*BJM # 8218*

**GFELLER LINE CONCENTRATORS**  
**49-9-2, 49-11 + 1-2, 49-12-2**  
**AUXILIARY AND APPLIQUE CIRCUITS**  
**DESCRIPTION**

**1.02** This section is reissued to revise Items C and I and to add Items J, K, and L. These changes cover information for the 49-11+1-2 and 49-12-2 models of the Gfeller line concentrator. The title has been changed accordingly.

Fig. 1

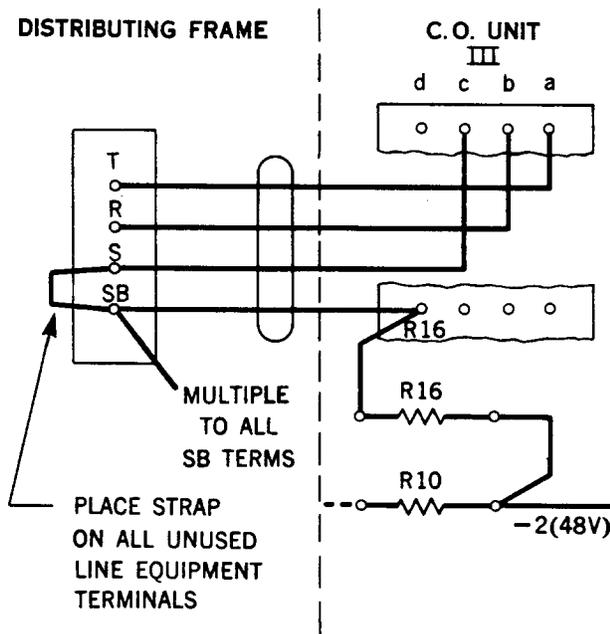
(a) Using the 6-32 bottoming tap, thread the spare hole in the resistor mounting strip below resistor R15.

(b) Mount the new 600-ohm resistor, using the 6-32 screw and washer. Designate the resistor R16 (to conform to the arrangement shown in schematic S10460-4, coordinates d9).

(c) Using a new wire, connect one terminal of the new resistor to the terminal of resistor R10 to which the black-white (battery loop) wire is connected. See Fig. 1.

(d) Using a new wire, connect the other terminal of the new resistor to a spare terminal in the lower half of terminal strip III. Designate this terminal R16.

Fig. 2

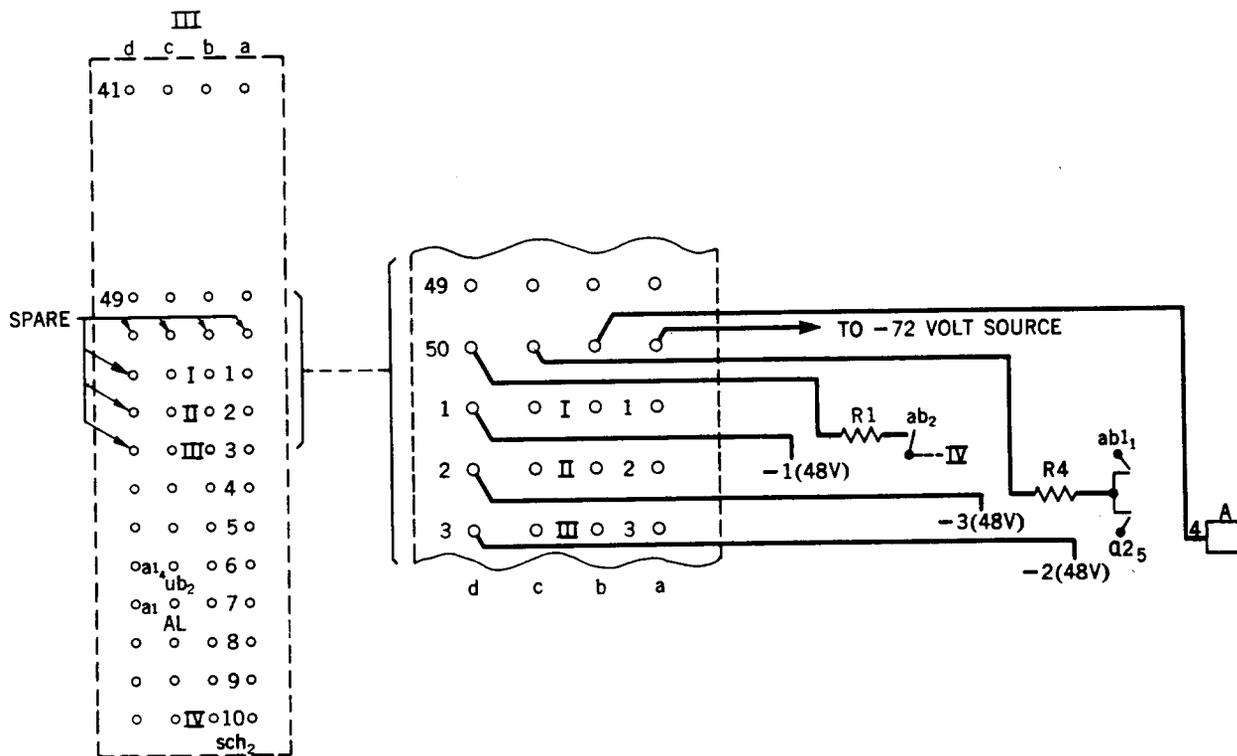
*Note:* Central office units modified prior to the issuance of Issue 2 of this practice have been wired per Fig. 2 and strapped per Table A. This information has been retained to aid in restrapping units already modified but it is recommended that future units be modified as given below.

Fig. 3

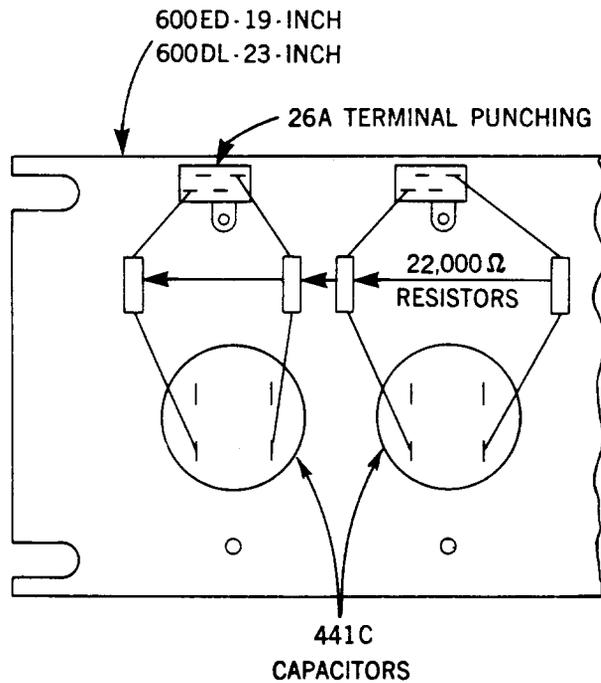
2.12 The components used and the manner of mounting and connecting the applique will depend on local conditions. The following arrangement is suggested:

2.13 441C capacitors, 26A terminal punchings and radio-type 22,000-ohm, 1-watt resistors may be assembled on a mounting plate as shown in Fig. 3 and wired as shown in Fig. 4. The applique circuits may be cabled (or wired with paired cross-connection wire through a locally provided ring run) to the line equipment terminal strip on the concentrator or on the distributing frame, to a separate block on the distributing frame and then cross-connected as required, or to the line links.

Fig. 5

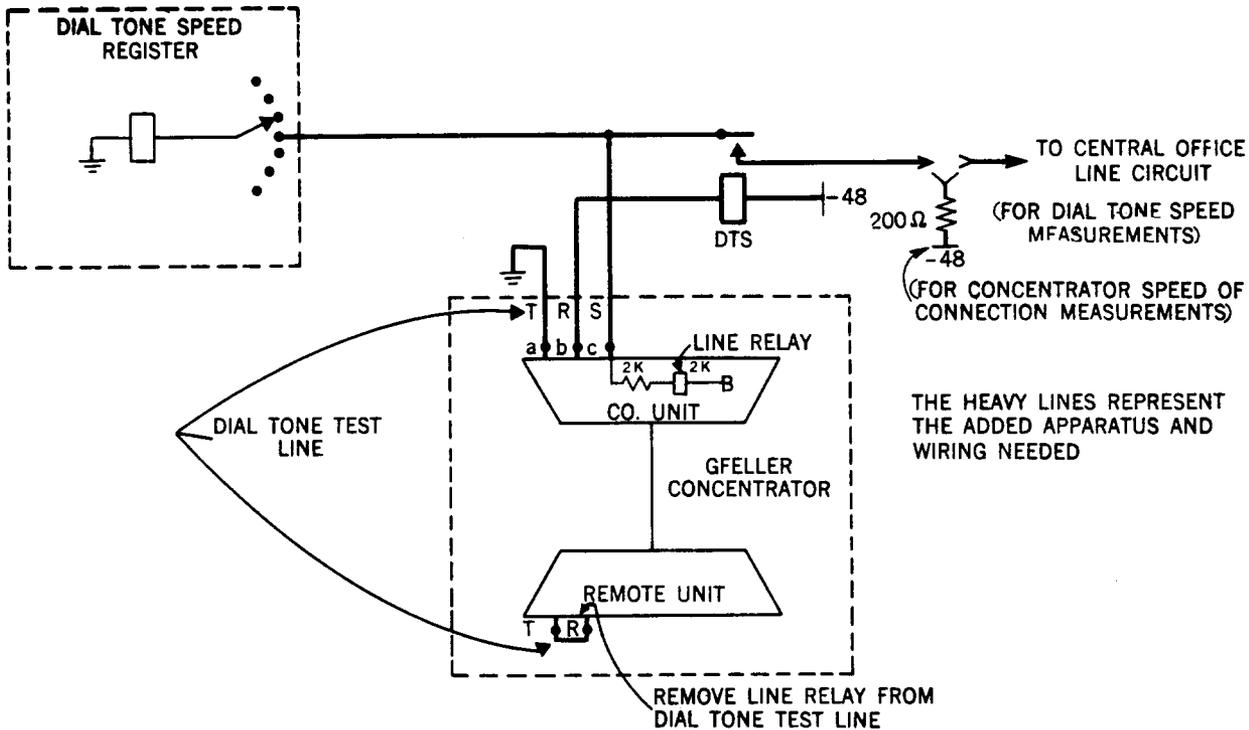
2.14 The circuit shown in Fig. 5 can be used to connect the dial tone speed register circuit to the concentrator. This applique requires:

- (a) Connection to the T, R and S leads of a spare line equipment in the concentrator and to the T or R lead of a spare central office line equipment.
- (b) Disconnection of the corresponding line relay at the remote unit.
- (c) Short circuiting of the T and R of this line at the remote unit.
- (d) Provision of an auxiliary relay (designated DTS in Fig. 5). This relay may be the same type as that used as a line-relay in the particular office and using the same requirements, or a Gfeller type (such as those with the designation BSU, BSG, or SCH) may be used.

Fig. 6

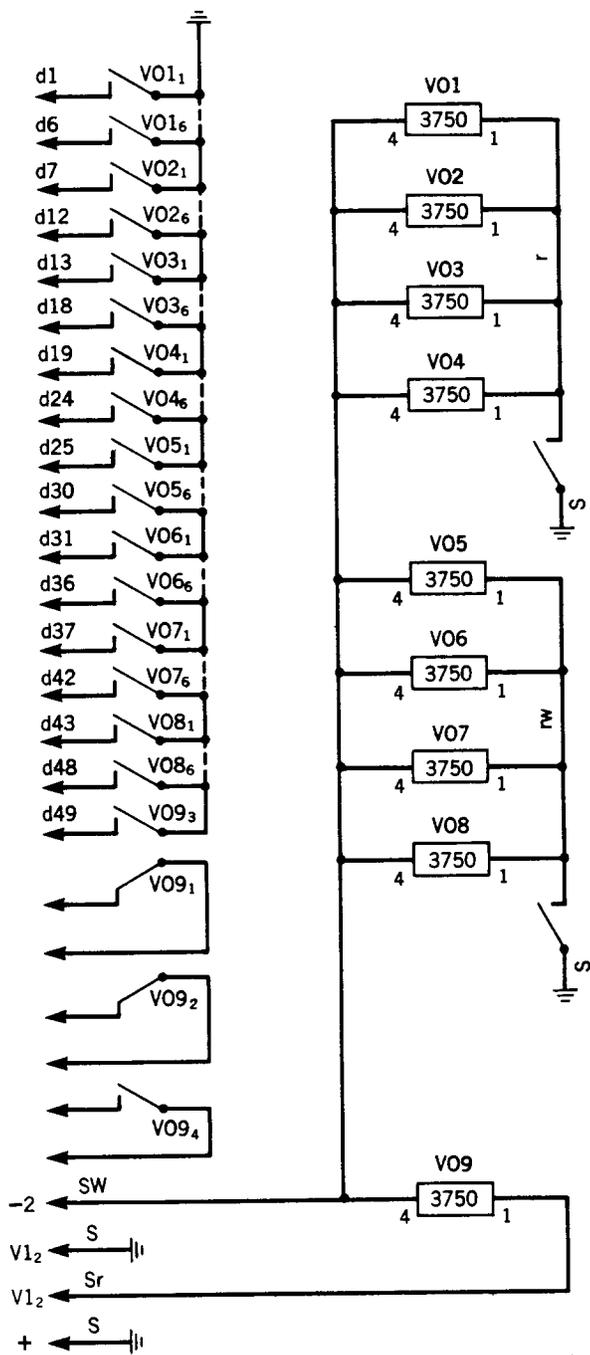
applies a ground to the sleeve of all idle lines when all concentrator trunks are busy, causing a busy signal to be returned on any incoming calls. It is applicable to 49-9-2 concentrators with the serial numbers from 448 up and to all 49-12-2 concentrators. A schematic of the circuit is shown in Fig. 6.

- (a) Battery feed loop (lead from winding terminal 4, VO9 relay) to -2 terminal.
- (b) Ground lead (wire designated + on Fig. 6) to + terminal.
- (c) The lead (wire designated V<sub>12</sub> on Fig. 6) from number 1 winding terminal of the VO9 relay to one of the V<sub>12</sub> terminals.
- (d) Connect the other V<sub>12</sub> terminal to + terminal (ground).
